**Engineering Review**

**EPC Planning & Community  
Development Department**

**FINAL DRAINAGE REPORT**

**BLACK FOREST OFFICE  
The North Half of the NE Quarter of the SE Quarter of Section 7  
Township 12 South, Range 65 West of the 6<sup>th</sup> P.M.  
County of El Paso, State of Colorado  
12740 Black Forest Road  
Colorado Springs, Colorado 80908**

**POND DETAILS**

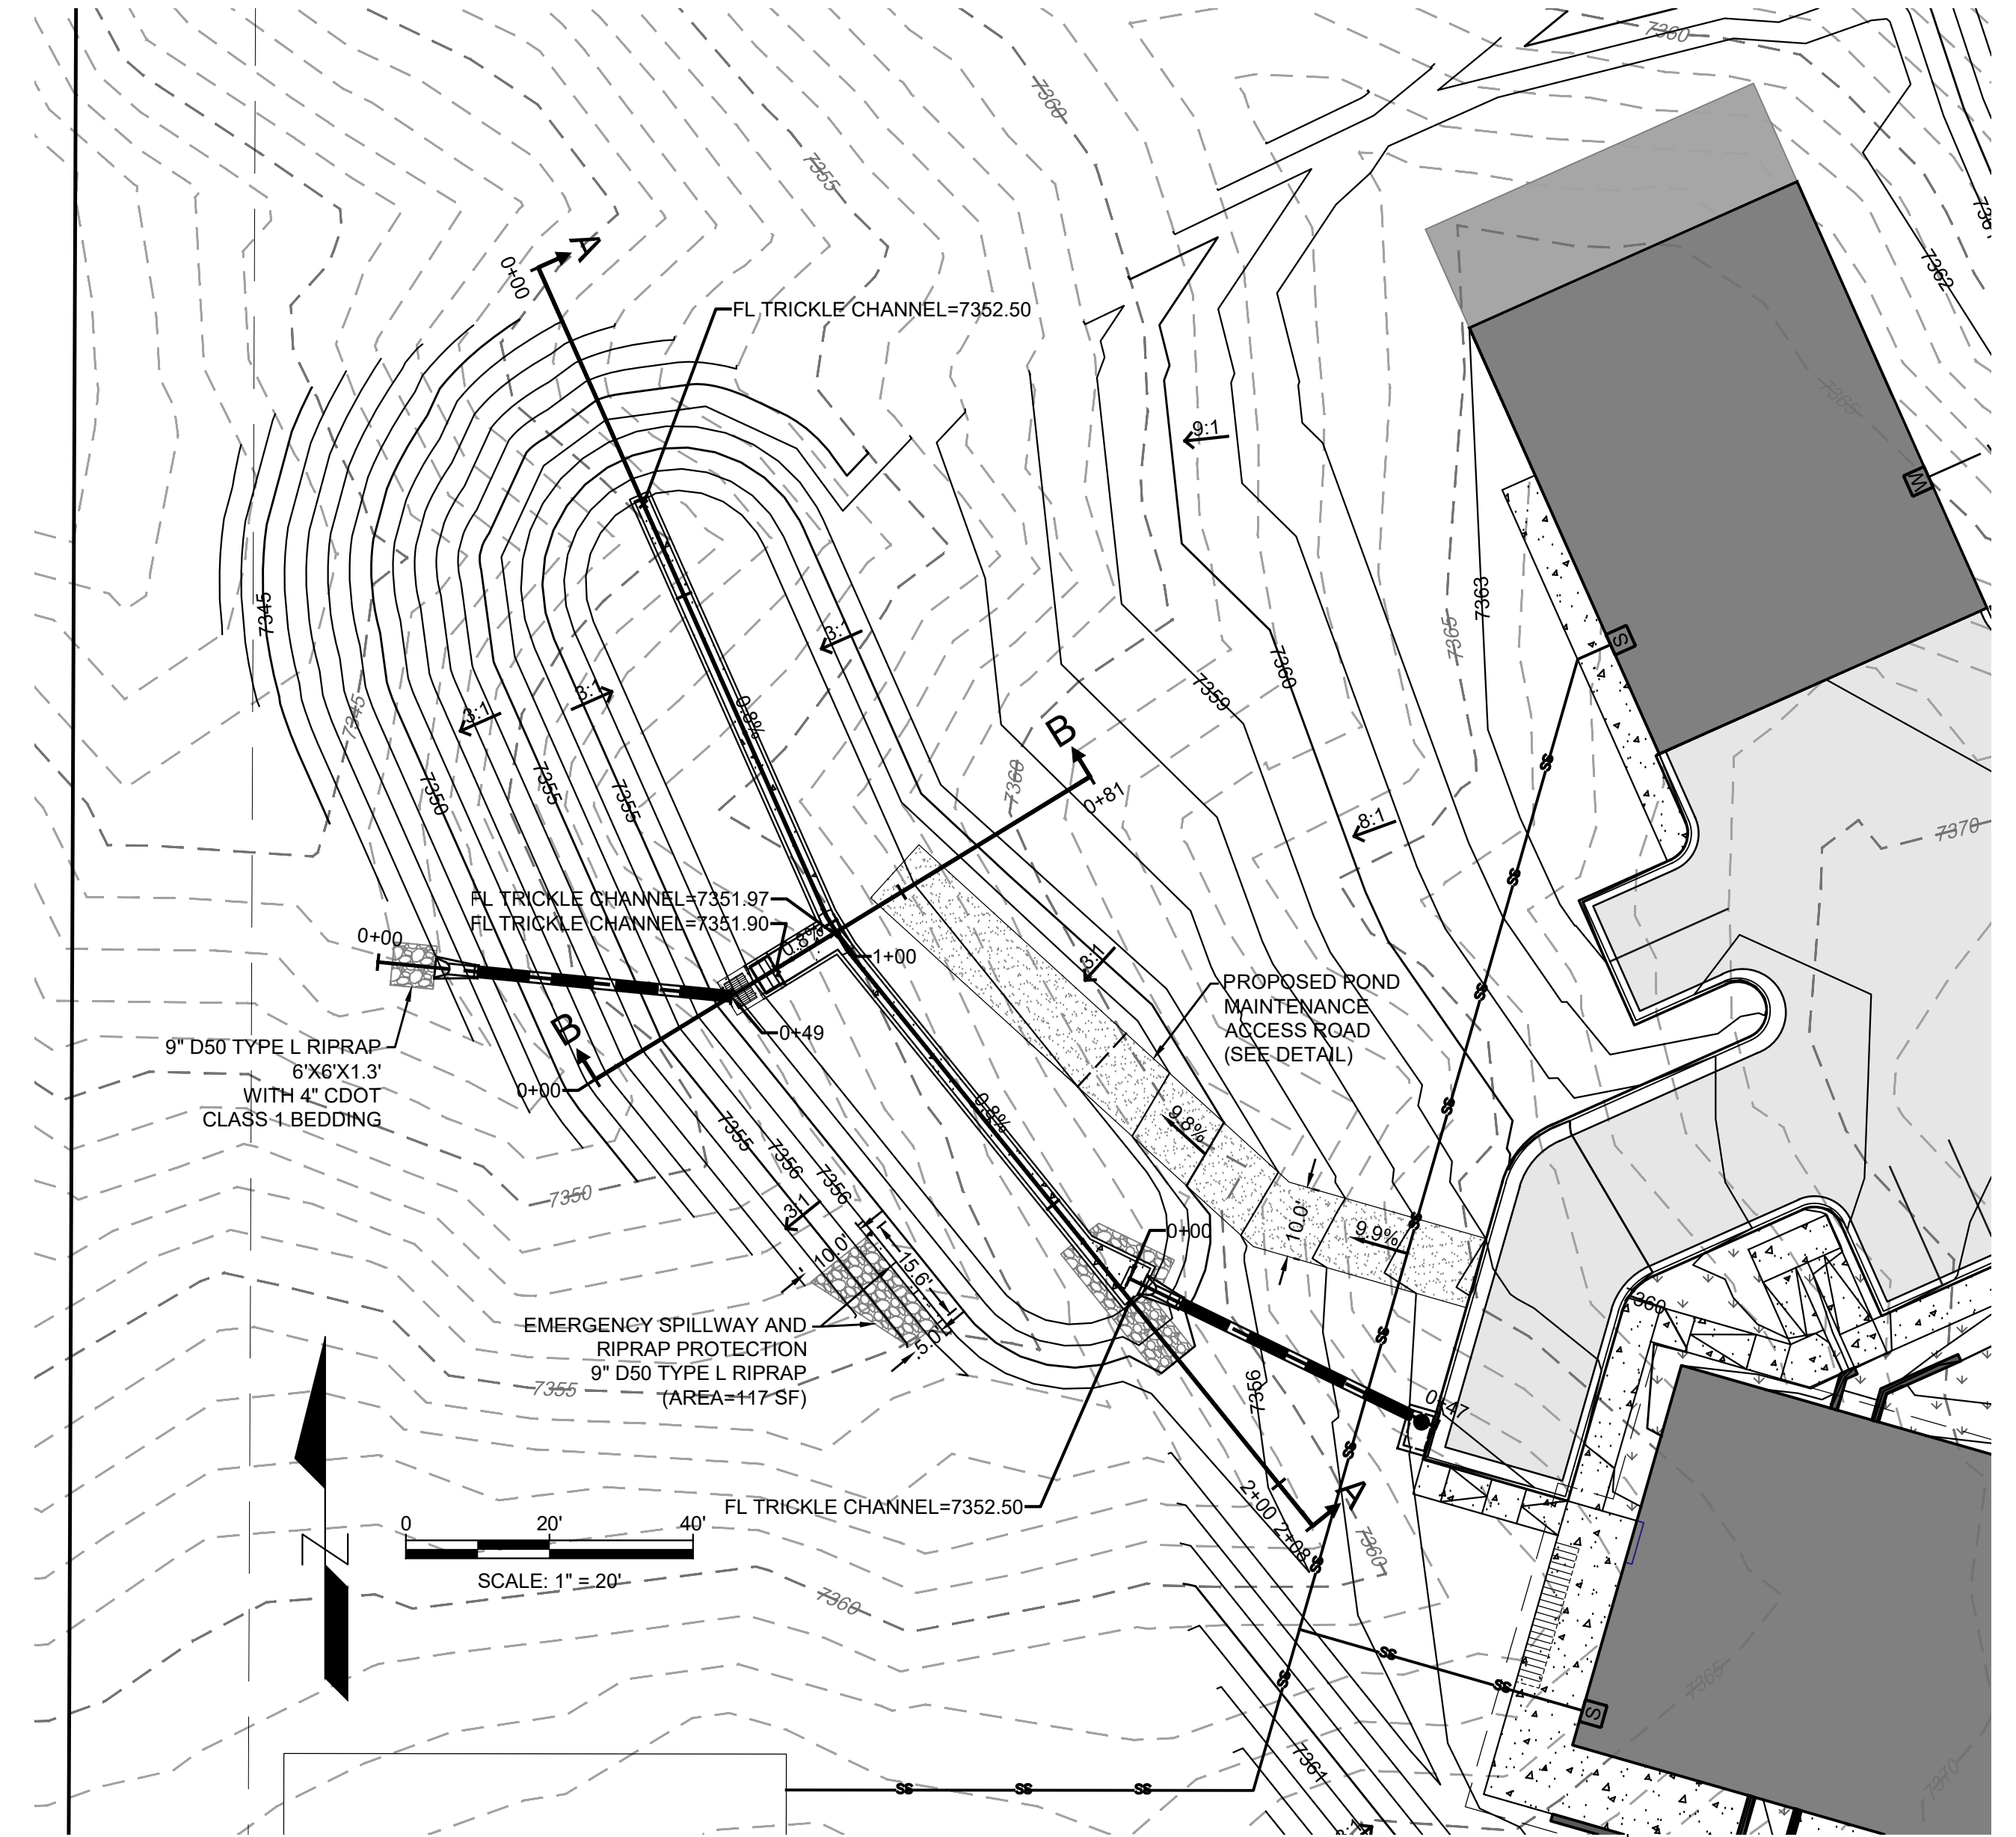
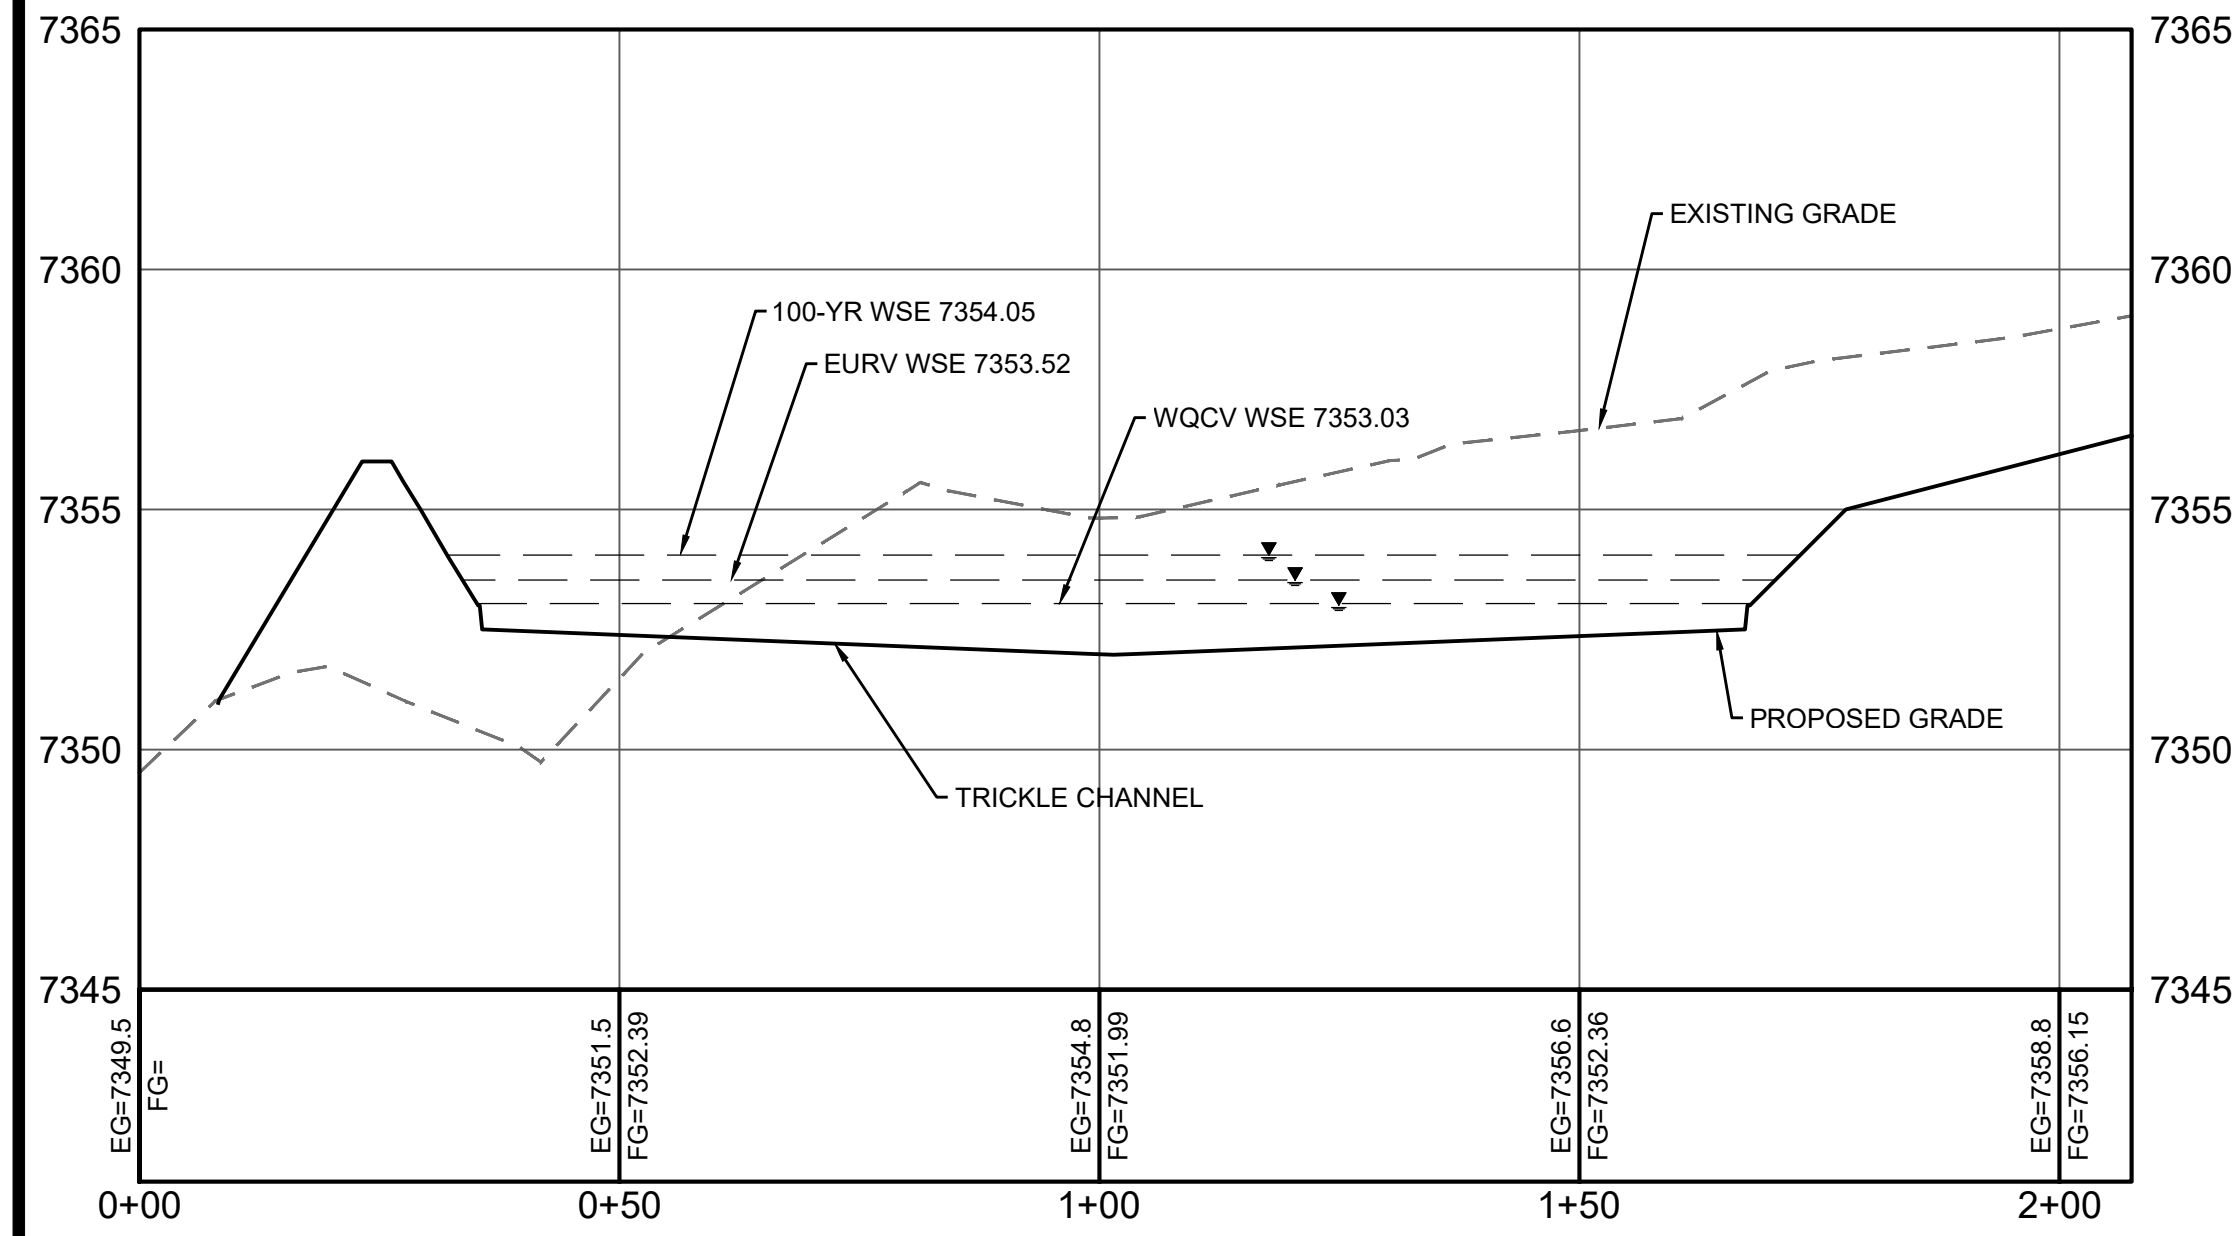
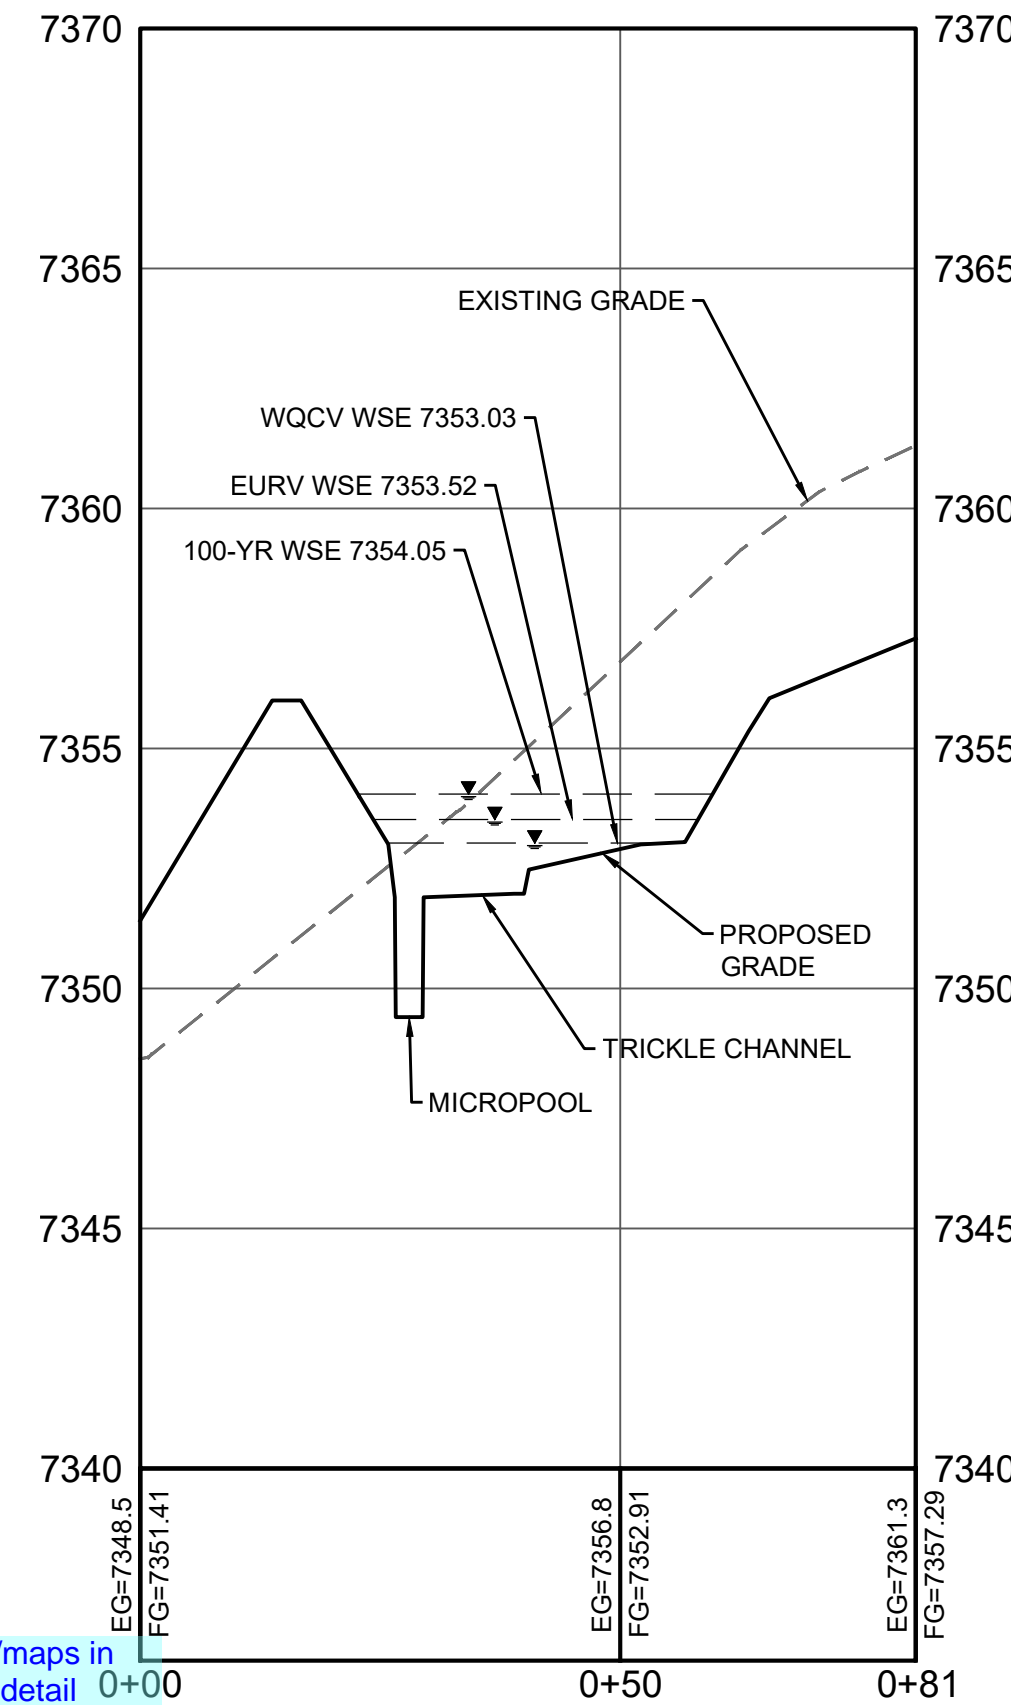
Provide two plan/maps in addition to these detail sheets. One to show historic conditions, one to show developed conditions.  
See checklist for all the criteria of these maps. Drainage basins off and on site etc.  
See note on page 19

Label the pipe size, side slopes, spillway, access road, etc.
